<p>CARNEGIE FORUM 305 WEST PINE STREET LODI, CALIFORNIA</p>	<p>AGENDA LODI SITE PLAN & ARCHITECTURAL REVIEW COMMITTEE</p>	<p><u>REGULAR SESSION</u> WEDNESDAY, JANUARY 12, 2011 @ 5:15 PM</p>
---	--	--

Item 3a

To: Site Plan and Architectural Review Committee
From: Immanuel Bereket, Associate Planner, Community Development Department
Date: December 8, 2010
Subject: Request for Site Plan and Architectural Review Committee approval to construct a sanctuary building for Crossroads-Heartland Church at 2223 W. Kettleman Lane. (Applicant, Delta Buildings, Inc., on behalf of Crossroads-Heartland Church; File # 10-SP-08).

To: Site Plan and Architectural Review Committee
From: Immanuel Bereket, Associate Planner, Community Development Department
Date: January 12, 2010
Subject: Request for Site Plan and Architectural Review Committee approval for a major remodel of an existing McDonald's Restaurant at 841 East Kettleman Lane. (Applicant, CRM Architects and Planners, Inc., on behalf of McDonald's USA, LLC; File # 10-SP-09).

A TRASH ENCLOSURE
SCALE: 1/4" = 1'-0"

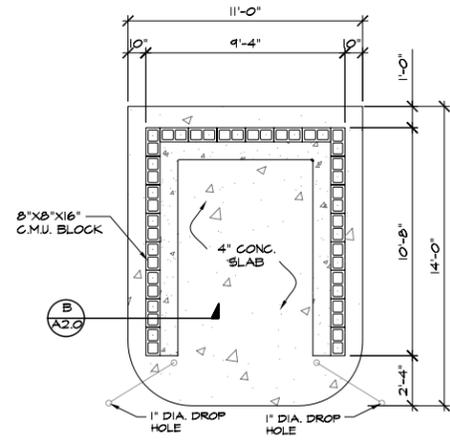
12. Landscape shall not obscure visual identification or building address.
13. The trash enclosure should be wide enough to provide separate containers for recyclable materials and other solid waste. The refuse enclosure shall comply with City standards, including dimensions and building materials, and include an area for recycling containers. Trash enclosure doors shall be solid steel doors and trash enclosure doors must remain closed when not in use.

SITE PLAN
SCALE: 1" = 20'

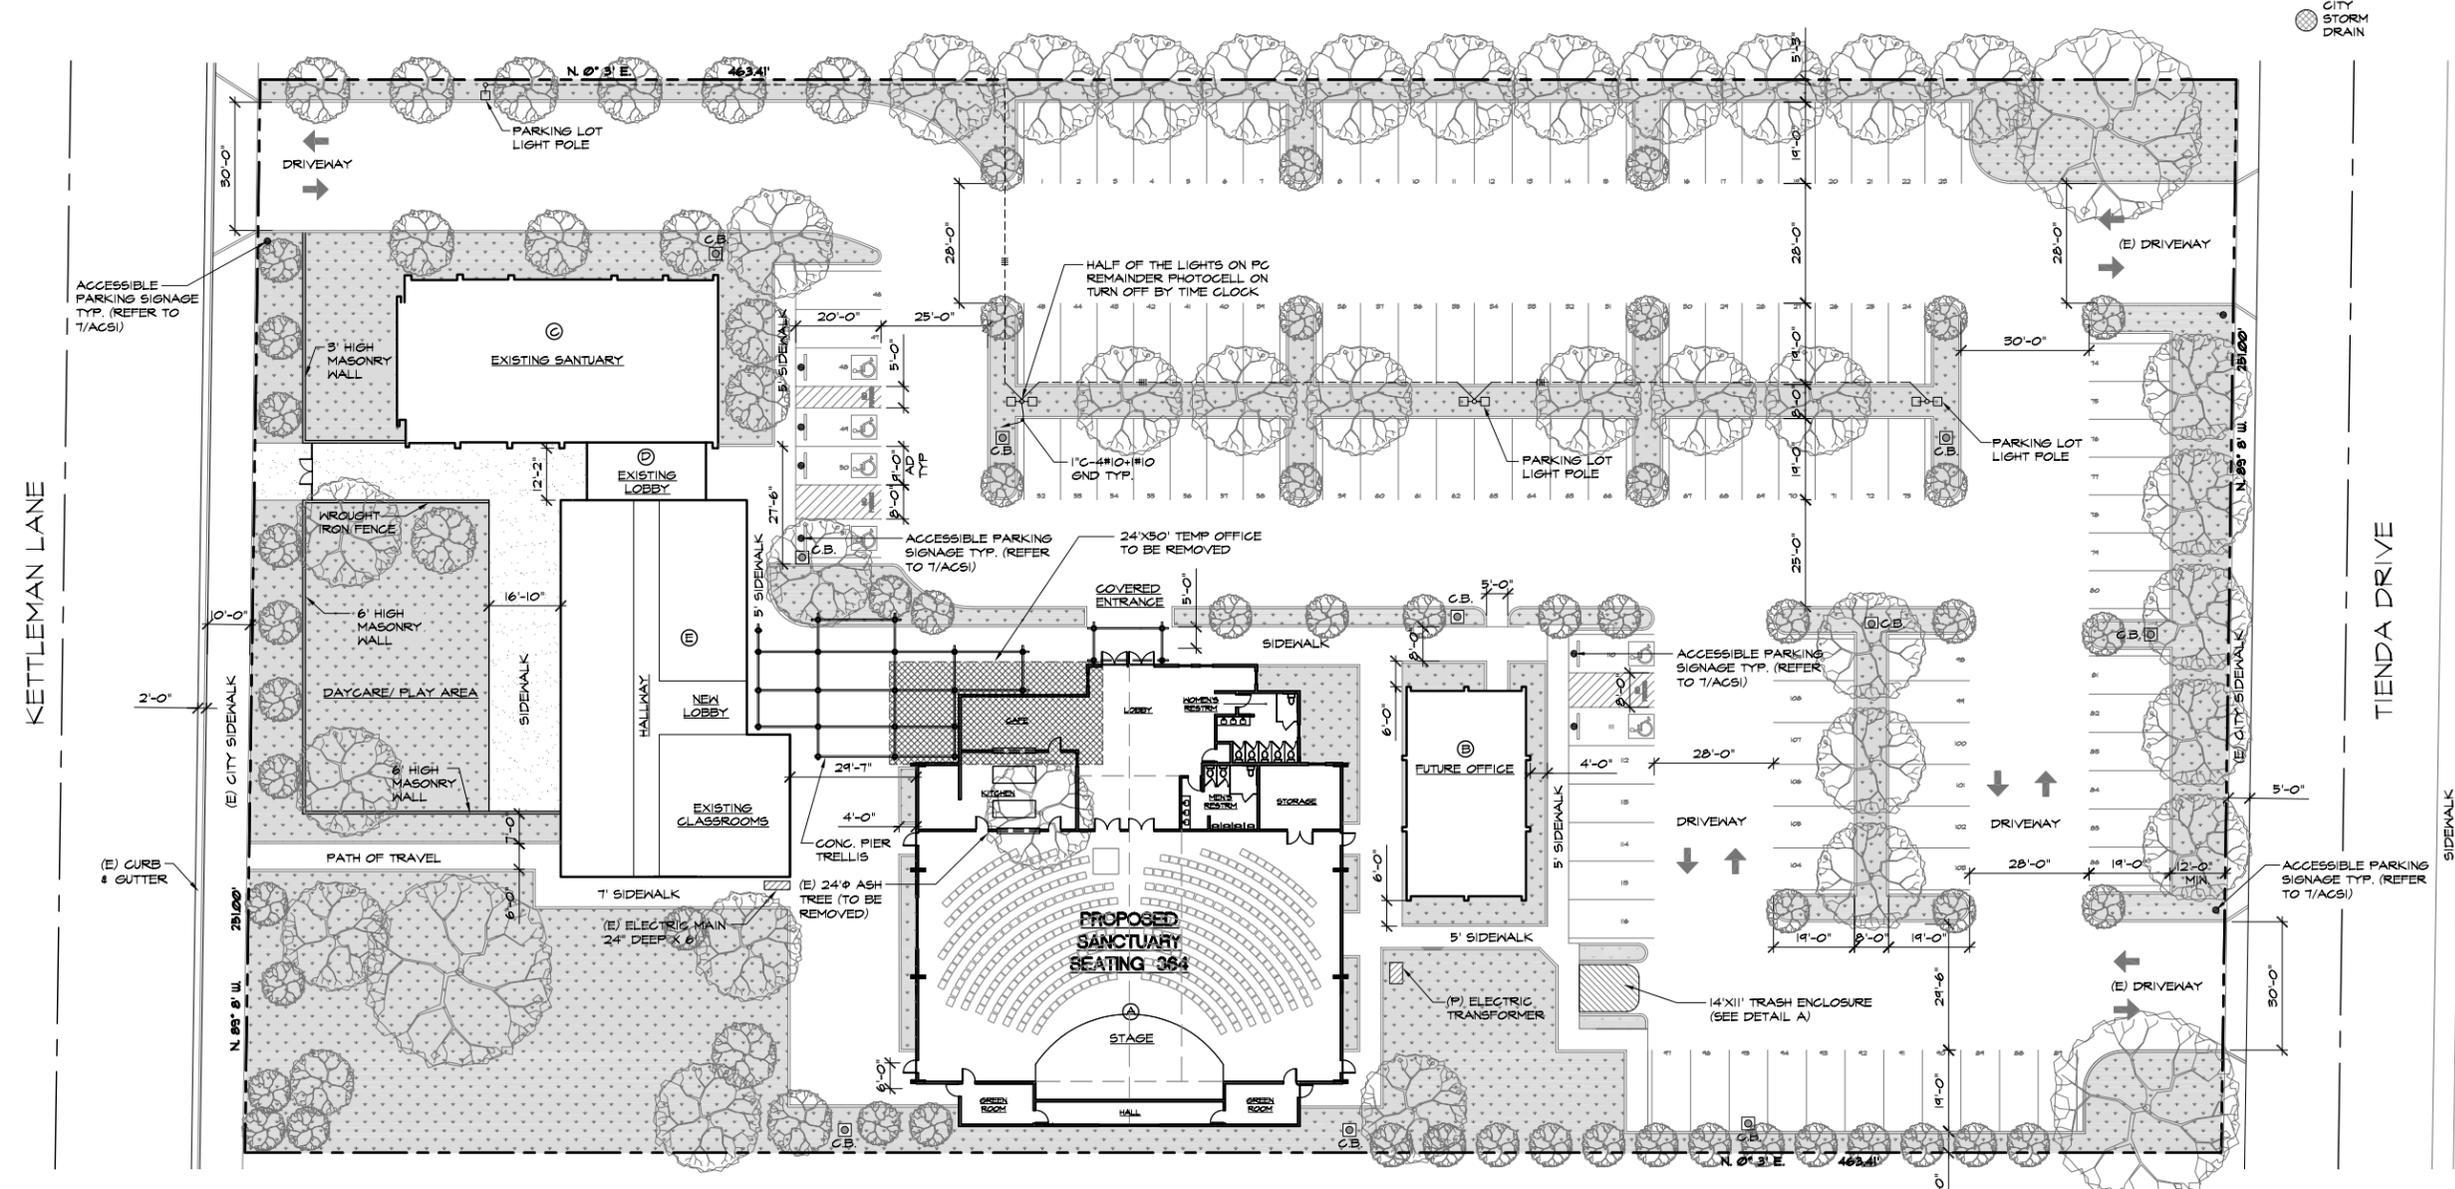
Parking Spaces – The proposed project would expand the existing parking lot and add a new parking lot at the northern end of the project site. The plans indicate that the new parking lot would be constructed in an area where partially paved and mostly unpaved area. Lastly, the location of the parking lot will be highly visible from Tienda Drive. The proposed parking meets minimum City dimensions.

Church sanctuaries are required to provide 1 space for each 4 permanently located seats per Zoning Ordinance *Section 17.60.100 (B)(3) Off-Street Parking Requirements*. The proposal will accommodate 400 seats ($400/4 = 100$ spaces). The Code also requires 1 space for each 250 of gross square feet of office space. The proposal includes 1,500 sq. ft of office space ($1,500/250 = 6$ spaces). City Code requires 106 parking spaces and the proposed development provides 119 total parking spaces.

Site Lighting – The proposed plans illustrate 4 parking lots poles. The plans do not show height of the poles and the type of bulb used. The proposed development would be required to submit site photometric plan during the building permit phase and must meet City Code requirements. Specifically, no bleed-over, wallpacks or other floodlights onto the neighboring properties would be permitted. Further, all building mounted lighting must include a 90-degree horizontal flat cut-off lens unless the fixture is for decorative purposes. The height of the poles cannot exceed 25-ft in height.. In addition, the main pedestrian walkway from Kettleman Lane should be illuminated with pedestrian scale lighting.

29. The following need to be shown and dimensioned on the site plan:
 - a. All existing public utility easements. Our records indicate that there is a 5-foot public utility easement (PUE) along the south property line, a 10-foot PUE along the west property line, a 26-foot PUE along the north property line and a 25-foot PUE along the east property line.

30. The parking layout shall conform to Standard Plan 134. End stalls shall have a minimum width of 10-feet and parking stall widths must be a minimum of 9-feet wide.

5. A photometric exterior lighting plan and fixture specification shall be submitted for review and approval of the Community development Director prior to the issuance of any building permit. Said plans and specification shall address the following:

- c) All parking light fixtures shall be a maximum of twenty-five 25 feet in height.
 - d) All fixtures shall be consistent throughout the center.
6. The applicant shall submit a landscaping and irrigation plan to the Community Development Department for review and approval. Landscaping materials indicated on the conceptual landscape and irrigation plan may be changed per the review of the Community Development Director or designee but shall not be reduced in amount.

LANDSCAPE PLAN
SCALE: 1" = 20'

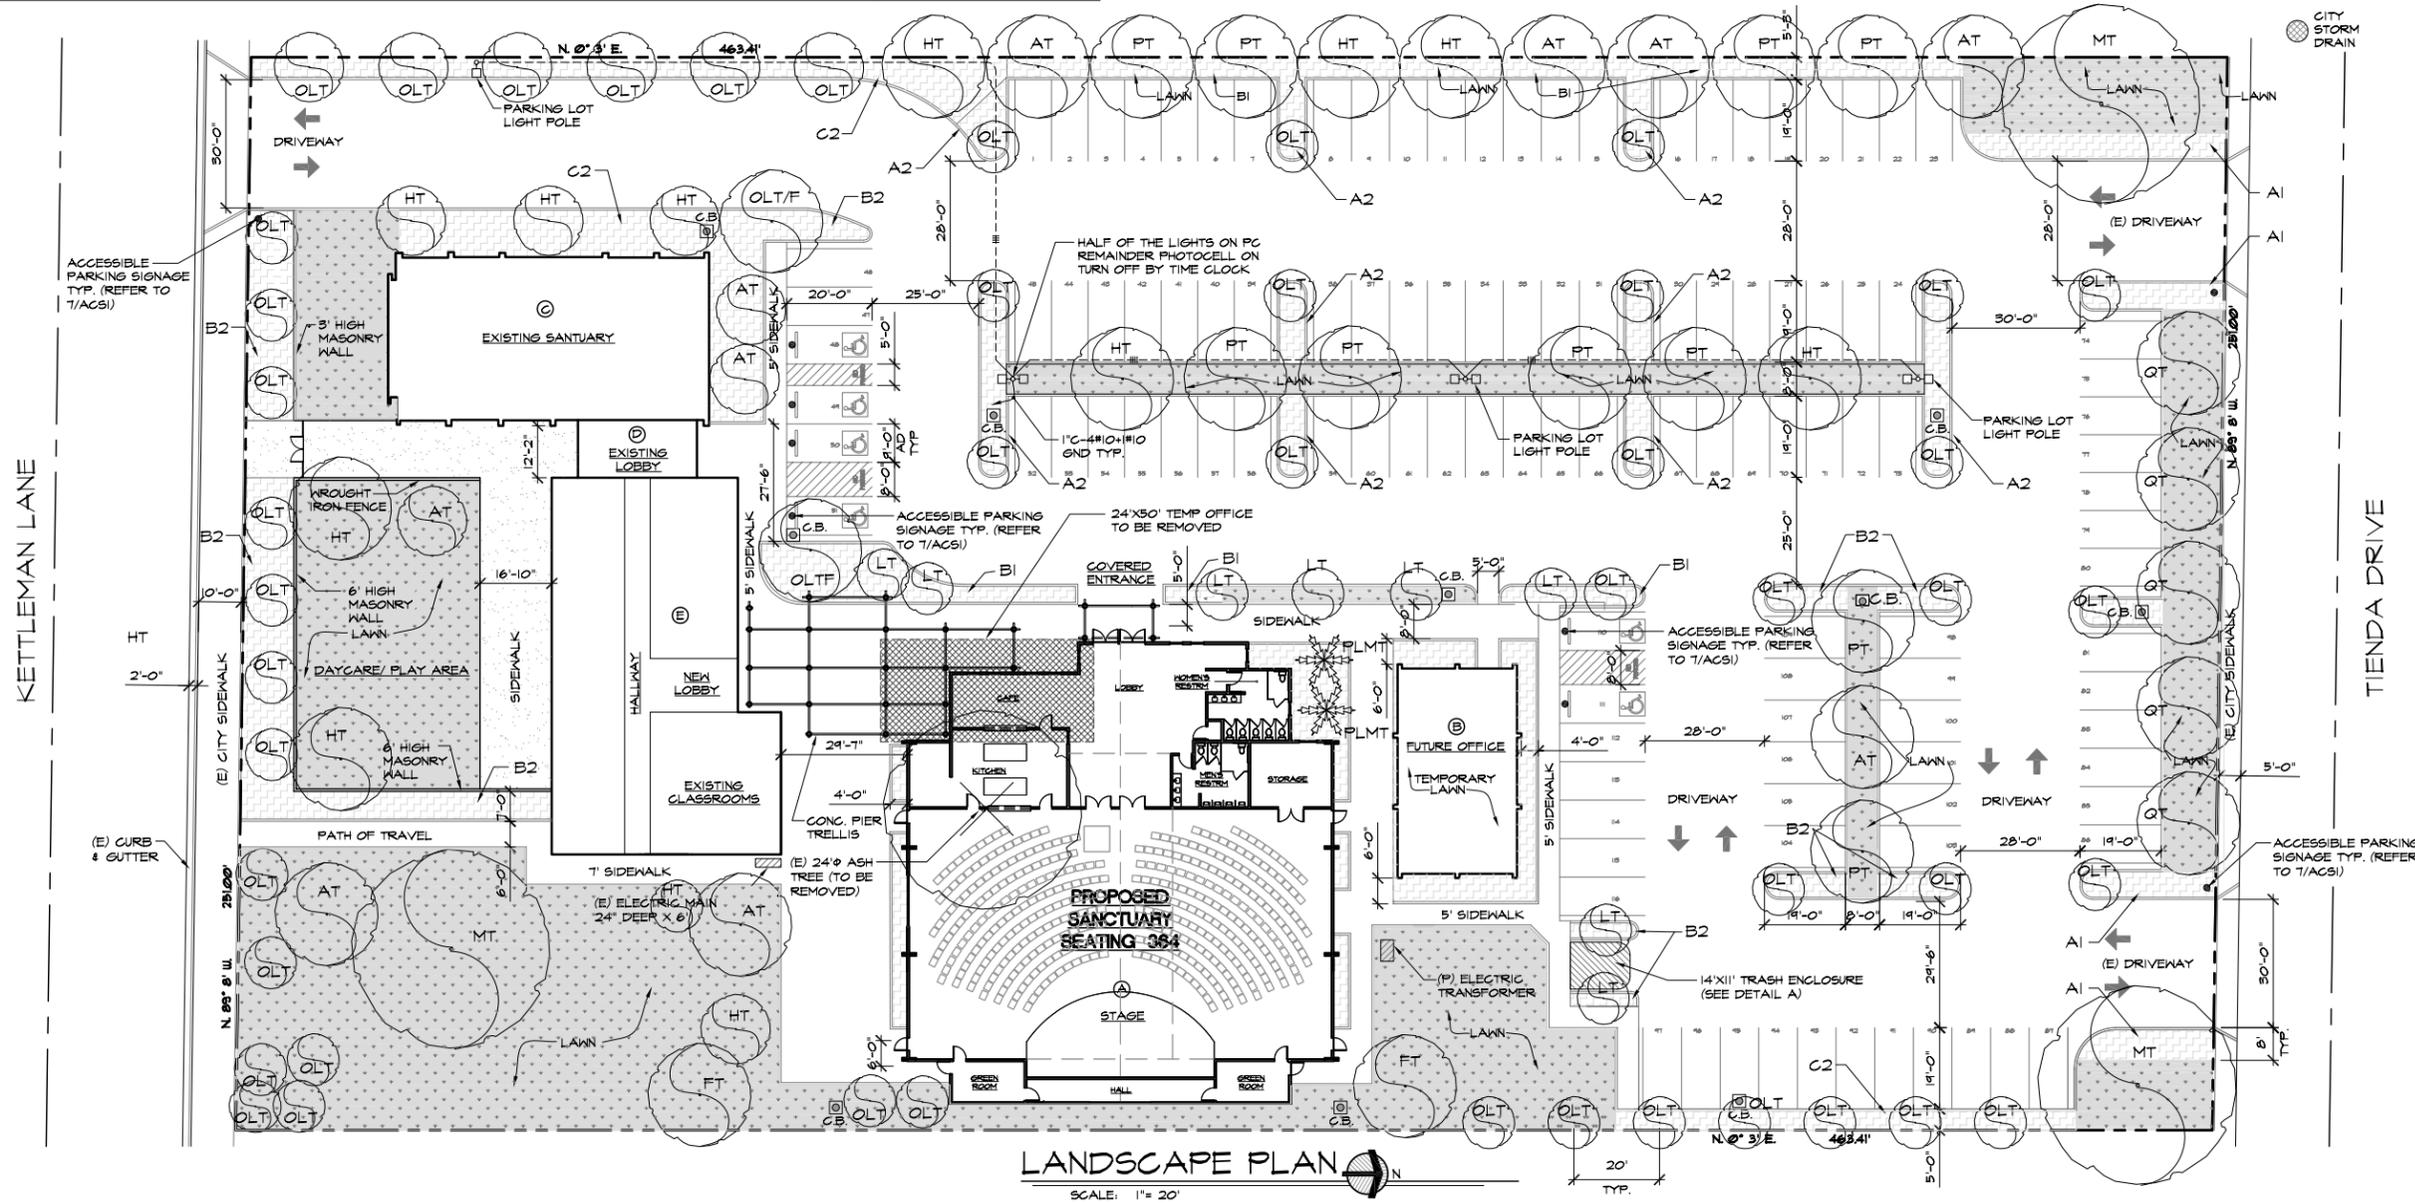
Landscaping – The applicant is proposing extensive landscape improvements for the site. The new landscaping would include approximately 56 new trees, including ornamental pear, oak, olive, maple, alder and palms. The proposed landscaping would include various species of shrubs and groundcover closest to the building designed to complement the building architecture rather than hiding it. A walkway and landscape buffer would be provided between the building and parking lots. While the proposal does not attempt to substantially augment the existing natural appearance of much of the site, staff recommends that additional landscaping be provided at the eastern boundary of the project site to better screen the project from adjacent residences.

Code requires one parking lot/shading tree for every 4 parking stalls and additional groundcover. Based on City ratio, the project is required to provide 30 large trees. The project provides approximately 56 various sizes of shading trees dispersed throughout the site, including the parking lot. The total landscape area comprises 72 percent of the site area, which exceeds the minimum required by the Code. The landscape material conditioned to relate to adjacent land uses and must utilize drought resistant species identified in the Local Government Commission's "Tree Guidelines for the San Joaquin Valley". Finally, it appears that the site would include more than 2,500 square feet of new or refurbished landscape area. Thus, the project will be required to comply with the Model Water Efficient Landscape Ordinance recently adopted by the State of California. Compliance with the ordinance could result in significant landscape modifications; thus, staff recommends that compliance with the ordinance be demonstrated prior to issuance of a building permit.

7. The applicant shall select and note on all plans common tree species for the parking lot and perimeter areas from the list of large trees as identified in the Local Government Commission's "Tree Guidelines for the San Joaquin Valley".
